Subject:     **WNP-2, OPERATING LICENSE NPF-21  
RESPONSE TO REQUEST FOR ADDITIONAL INFORMATION  
RELATED TO INDIVIDUAL PLANT EXAMINATION FOR  
WASHINGTON PUBLIC POWER SUPPLY SYSTEM (WPPSS)  
NUCLEAR PROJECT NO. 2 (WNP-2)**

**RESPONSE TO REQUEST FOR ADDITIONAL INFORMATION RELATED TO  
INDIVIDUAL PLANT EXAMINATION FOR WNP-2**

## ADDITIONAL INFORMATION RELATED TO INDIVIDUAL PLANT EXAMINATION

LOSS OF OFFSITE POWER EVENT TREE	
FIGURE 3.1.2.1-7.2	
AUTHOR _____	DATE _____
REVIEWER _____	DATE _____

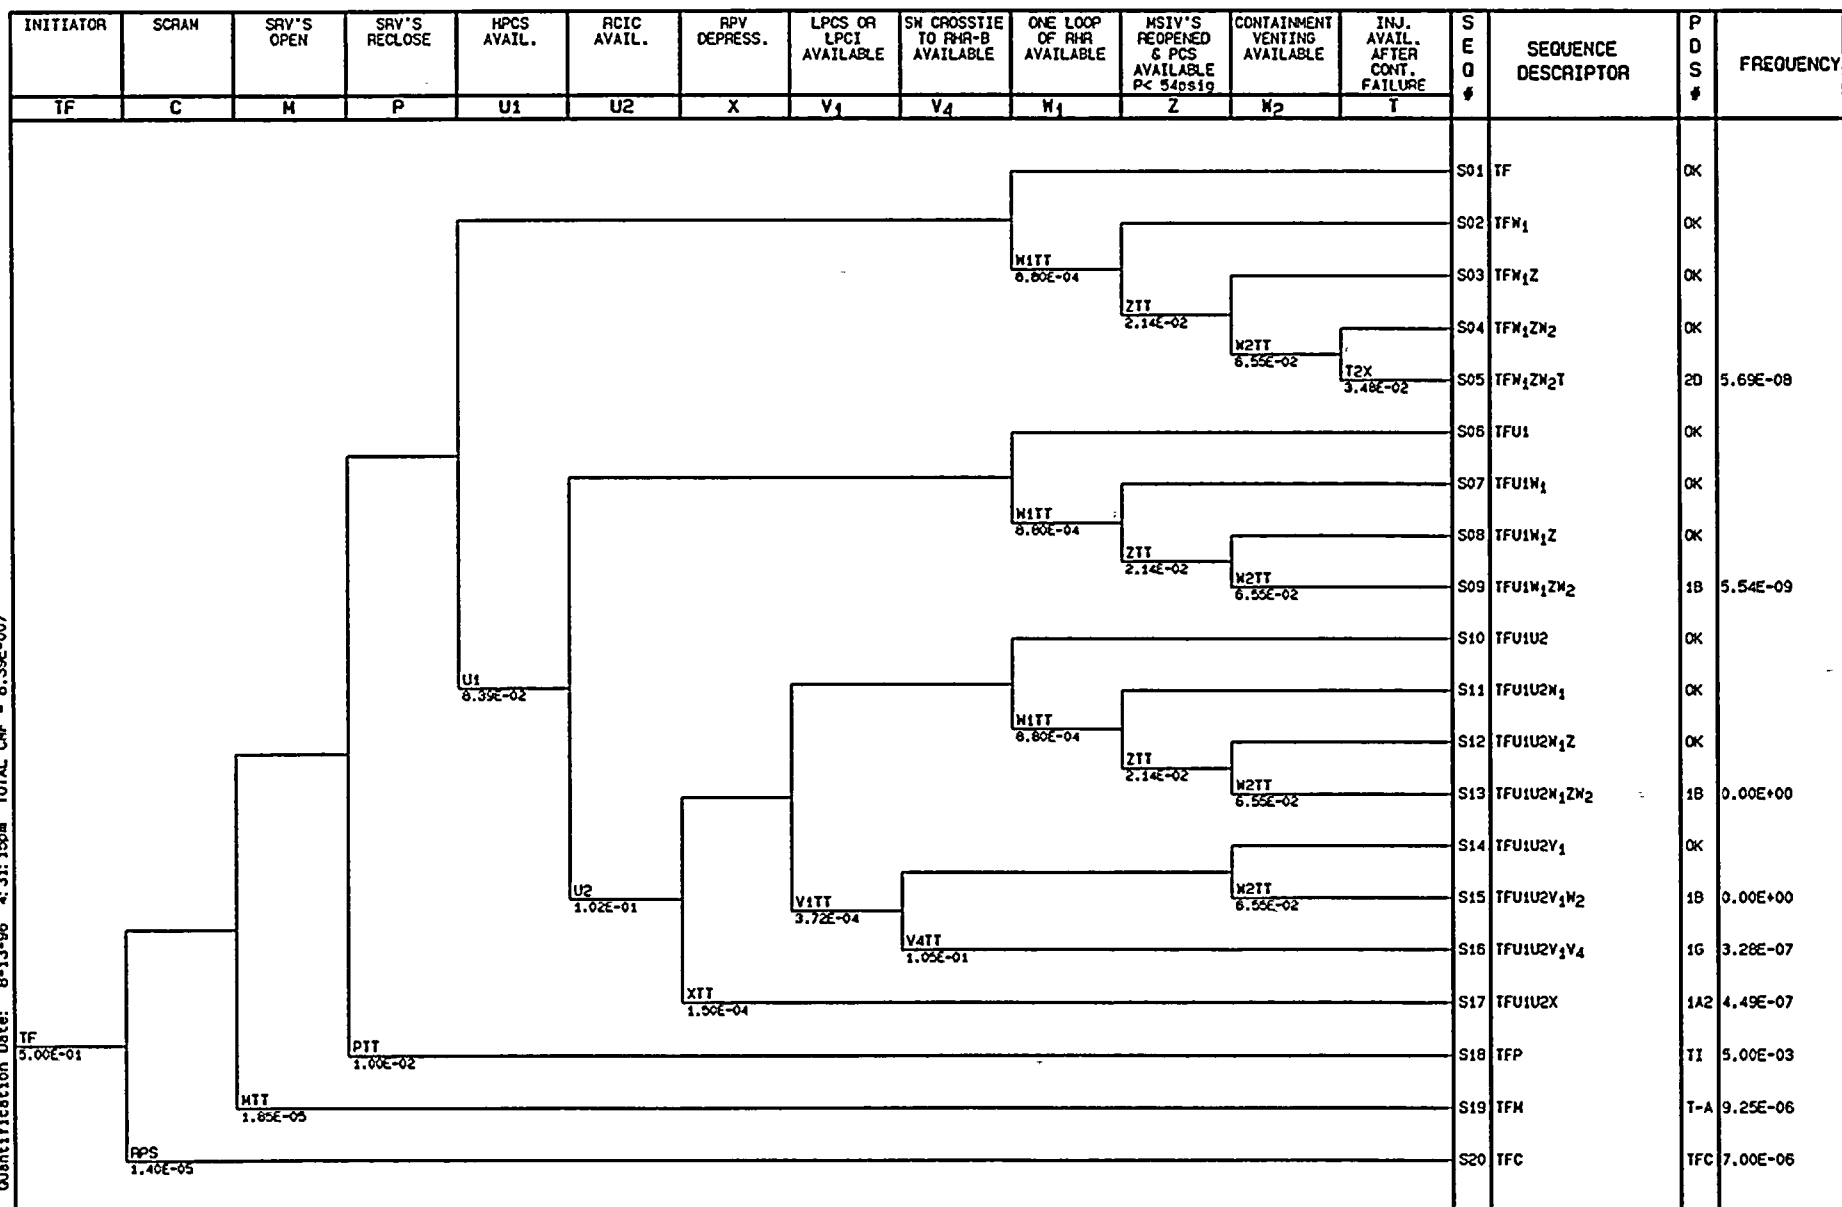
The use of the fire water system for injection to the core was credited on a very limited basis in the licensee's IPE. Specifically, fire water was not credited for station blackout although it has diesel driven pumps independent of AC power. The intent of Generic Letter 88-20, however, was for the licensees to identify instances of plant cost-effective improvements reducing the CDF. Since Station Blackout contributes 61.0 percent to the total CDF, it appears that it would be reasonable for the licensee to consider improvement(s) enabling the use of fire water during station blackout. Please explain why you did not address the use of fire water during station blackout as part of the IPE improvement effort.

Revision 2 includes the use of fire protection water in the short term station blackout scenario (see the TE event tree attached to the response for question 2, Branch V<sub>3</sub>). As directed by the Emergency Operating Procedures (EOPs), if the reactor water level falls to the low, low (L1) setpoint, the operator will ensure two or more systems are injecting from the preferred list of systems (i.e., Condensate, HPCS, LPCS, RHR-A, RHR-B, RHR-C). If these systems fail, then he will start alternate injection systems such as, RHR/SW Crosstie and/or Fire Protection Water. The Human Reliability Analysis shows that the time required for connecting fire protection water to the condensate system is approximately 70 minutes. For the General Transients and LOCA cases, the diagnosis time for human action starts after water level has dropped below L1 and there has been no successful low pressure injection. Therefore, after the operator realized that the preferred list of systems and RHR/SW Crosstie have failed, there is not sufficient time for him to connect the Fire Protection Water to prevent core damage.

Credit for FP water was only taken in the short-term Station Blackout sequence in which the operator would start to diagnosis the plant conditions at post-scrum water level (L3). In this scenario, the operator would have noticed that high pressure injection systems failed to initiate at L2 and knows the other low pressure systems are not available due to blackout conditions. Therefore, there is sufficient time for the operator to diagnosis the problem and make the decision to depressurize and lineup the Fire Protection water. During the long-term SBO scenario, the containment pressure may be too high and preclude the use of the depressurization system (see response to previous question on core cooling/containment heat removal interface). Therefore, the Fire Protection water was not credited for this scenario. As noted in our response to Question #8 of the RAI, the IPE report text is not consistent. The proposed text changes are attached and will clarify the use of Fire Protection water in the PSA.
